## **FIA Comments on Draft Recommendation on Software Updates of the Task Force on Cyber Security and Over-the-air issues of UNECE WP.29 GRVA**

Informal document GRVA-01-18 1st GRVA session

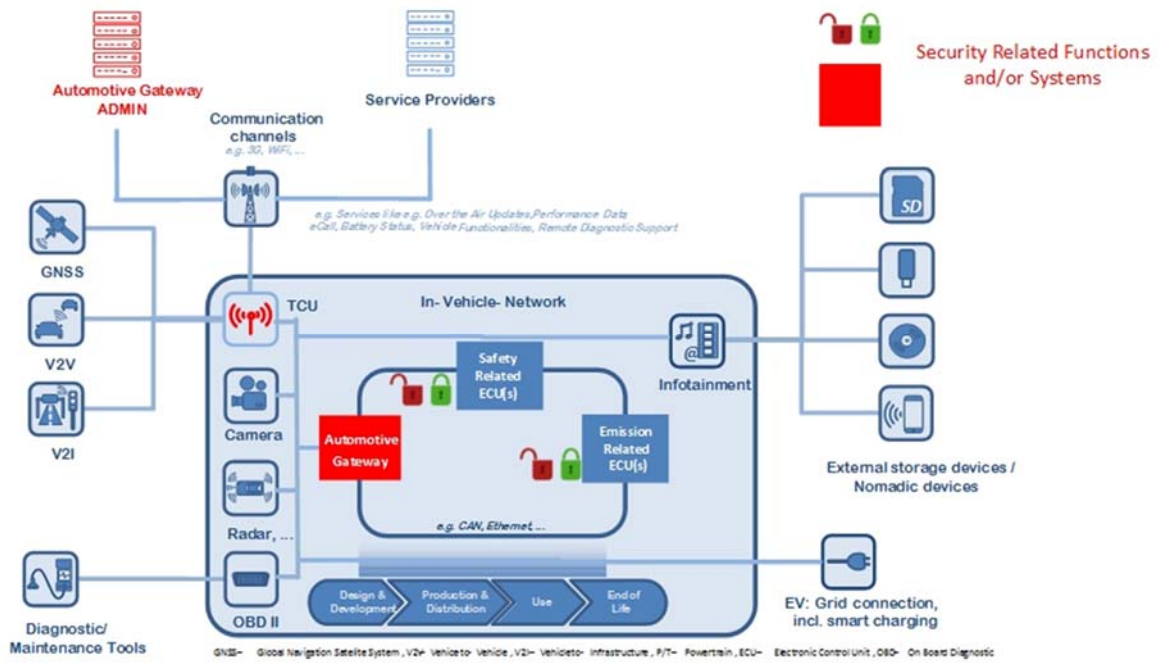
- 1) Automated Vehicles need not only soft- but also hardware updates. The parent group (GRVA) should decide about an extension of the mandate to include hardware updates too.

FIA club ADAC showed, that the Keyless Entry systems are unsecure. By simply extending the range of the signals the vehicles can be opened and driven away. Only a change of soft- and hardware could solve the problem for the existing fleet. VW, Fiat, Honda, Kia and Volvo had vulnerabilities in key codes of millions of vehicles. Replacing the keys (hardware), affected by the vulnerability was too costly for the vehicle manufacturer.
